ADDRESS : 88579 *UNASSIGNED
CONTRACTOR :
OWNER : SNEAD GREG N & MARTHA J
PARCEL : 05-0626- - -0059- -07-
APPL NUMBER: 08-50020205 CP NEW RESIDENTIAL (SFD)
DIRECTIONS : 42 HWY TO ROLLINS MILL RD 3RD LOT ON
LEFT JB

STRUCTURE: 000 000 73.5X91.10 4BDR BASEMENT W/GARAGE & DECK
FLOOD ZONE : FLOOD ZONE X

Re: 155 Rollins Mills Rd Permit 08-50020205
Jampe Job Number 0810-48

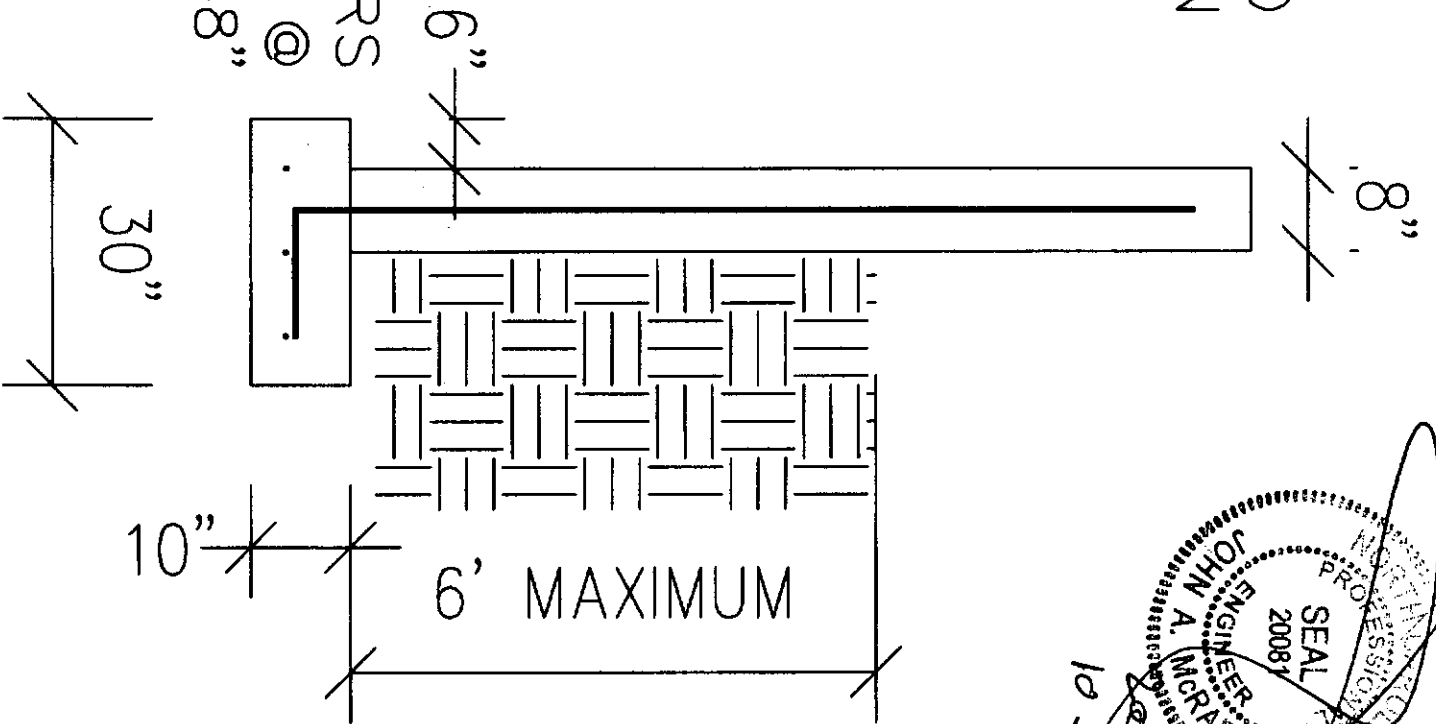
#4 @ 16
VERTICAL
AND HORIZ

3-#4 BARS
CROSS @
48"

ROOF OVERVIEW

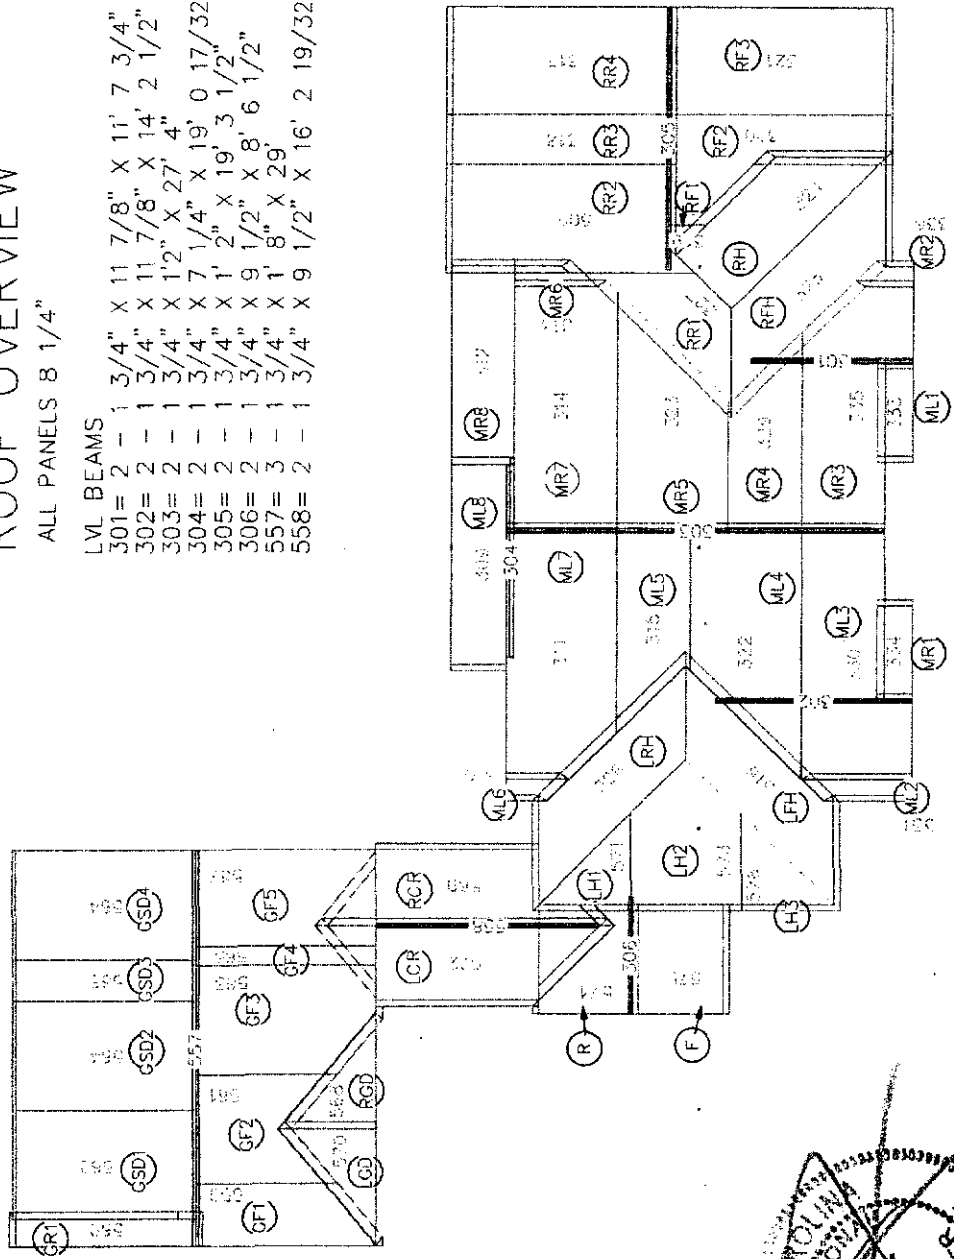
Builder has used Structural Insulated Panels (SIP) for wall and roof construction -
2 x 6 wall provides minimum of R-24 Thermal envelope. Roof insulation exceeds R-35 required
including vaulted areas. Roof support per attached layout. **Meets requirements of IRC 2003**
(NCBC 2006)
